Office Action Summary

DETAILED ACTION

FREEZE PROTECTION FOR HEAT PUMP SYSTEM
Applicant: Sienel; Serial No. 10/725,732
REPLACEMENT DRAWINGS

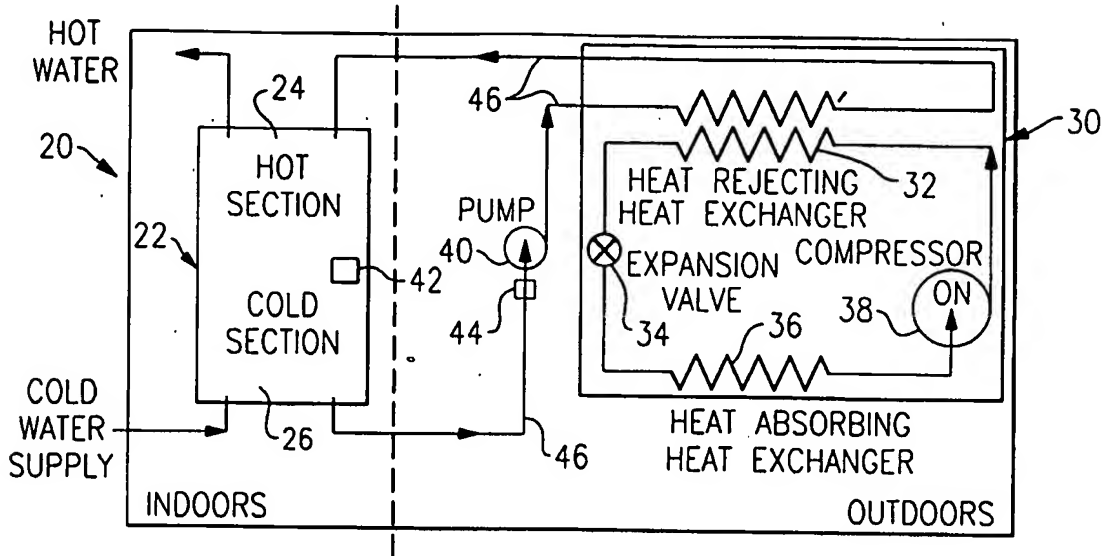
5. The drawings filed on January 8, 2007 are also objected to under 37 CFR 1.83(a). The drawings must show every feature of the invention specified in the claims. Therefore, the following features must be shown or the features canceled from the claims: a control for the pump as newly recited in claims 1 through 5 and 10 through 14; and, a temperature sensor which senses an ambient outdoor temperature as newly recited in claims 13 and 14. No new matter should be entered.

Corrected drawing sheets in compliance with 37 CFR 1.121(d) are required in reply to the Office action to avoid abandonment of the application. Any amended replacement drawing sheet should include all of the figures appearing on the immediate prior version of the sheet, even if only one figure is being

FIG.2

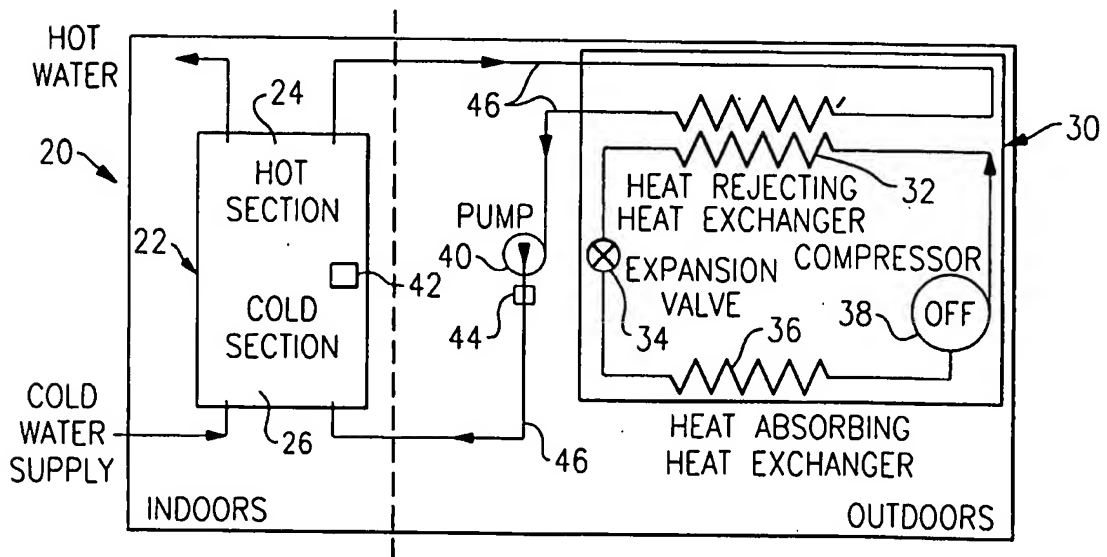
4. The replacement drawings were received on January 8, 2007. These replacement drawings are NOT approved because, in addition to various objections explained in greater detail below, the replacement drawings contain new matter. In particular, Figure 2 of the replacement drawings shows refrigerant as flowing through the heat pump refrigerant circuit when compressor 38 is OFF; this constitutes new matter because, for example, the originally filed drawings (i.e., the drawings filed on December 2, 2003) do not show any refrigerant flow through the refrigerant circuit of the heat pump when compressor 38 is OFF.

not approved.
AVC
8-31-07
